Orica Southlands Remediation and Redevelopment, Banksmeadow

Transport Assessment Review

July 2011

Figure 4.4: Orica's Proposed Hill Street Intersection Layout

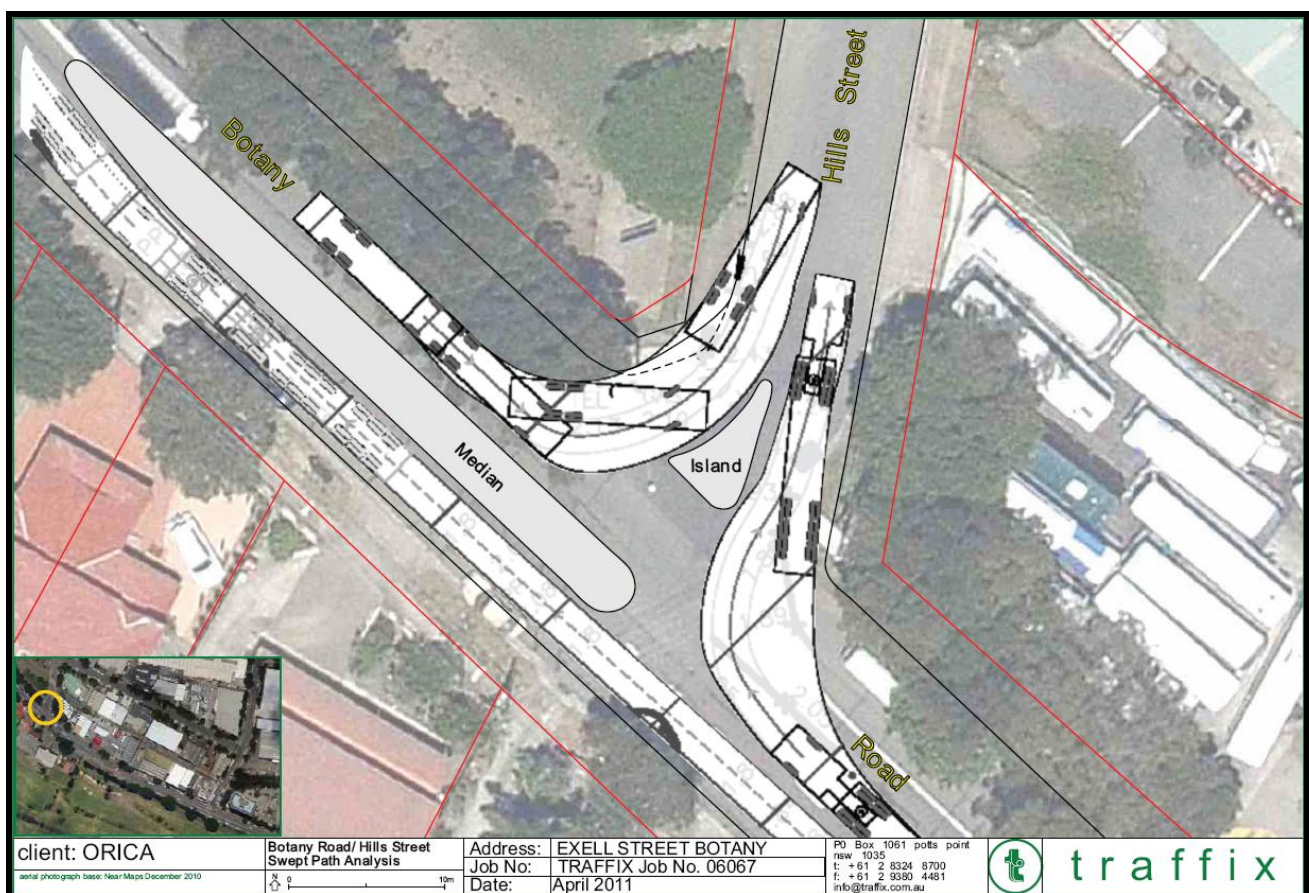
- The RTA cannot support the proposed layout of the Hill Street intersection, which allows for simultaneous left and right-turn movements off Botany Road – refer to Figure 4.4 below.

Orica have mentioned that the Hill Street design they submitted should be seen as an 'in-principle' design (attached to a suitable condition of consent) with detail design at a later stage to satisfy RTA and Council requirements. This 'conditioned' approach may be an alternative course of action.

Orica, via their specialist traffic consultants Traffix, responded to the above RTA comments (correspondence dated 14 July 2011) by stating that they support RTA's recommended improvements / layout.
